Additional Site Investigation Work Plan

Greentree Cleaners 5111 Douglas Avenue Racine, Racine County, Wisconsin

DNR FID # 252138700 DNR BRRTS #02-52-579863

June 28, 2021

Figure 1: Vapor Point Sample Locations

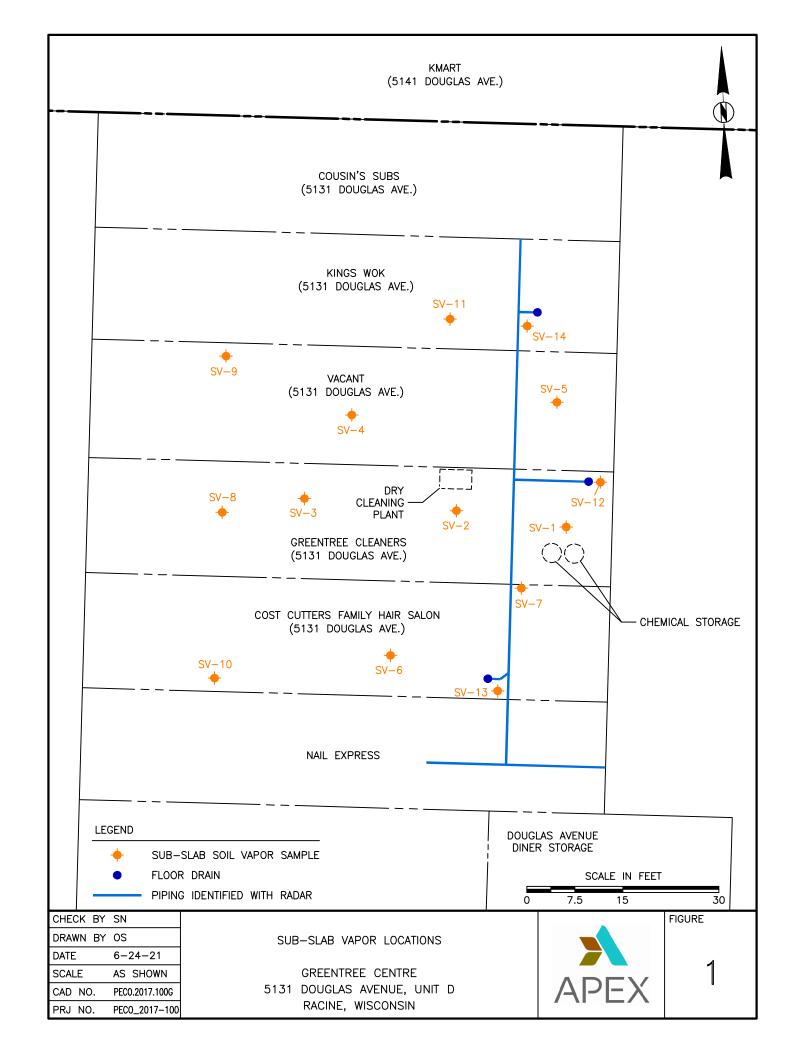
2. Evaluate the utilities below the building to establish if they are providing a vapor conduit to other portions of the building. Floor drains in the restroom(s) or kitchens, in the

drycleaner space and in adjoining businesses were not discussed as potential discharge areas or pathways for vapor movement to other indoor air spaces. The vapor contamination found in SV-11 indicates a possible impact from a preferential pathway such as a utility line. Provide a diagram of all the utilities within the building, as a whole, to include all the adjacent businesses. Particular attention should be paid to the water main and sanitary sewer. Include the estimated areas of soil, groundwater and vapor contamination to support the utility pathway evaluation. Propose additional vapor sampling points required to investigate these pathways, based on this evaluation.

Apex and our subcontractor performed ground penetrating radar (GPR) surveys within the tenant spaces adjacent to the dry cleaner. Based on the survey, we prepared the attached **Figure 1** with the interpreted utility lines beneath the building floor slab. The lines identified are believed to be sewer and water lines that run generally north and south from one tenant space to the next. It should be noted that SV-7 was already sampled immediately adjacent to the lines running south of the drycleaner. However, to further assess the potential vapor migration along these utilities, Apex proposes two new vapor points (SV-13 and SV-14) as shown on **Figure 1**. Section 3 below provides more detail on the sampling of the two new vapor points.
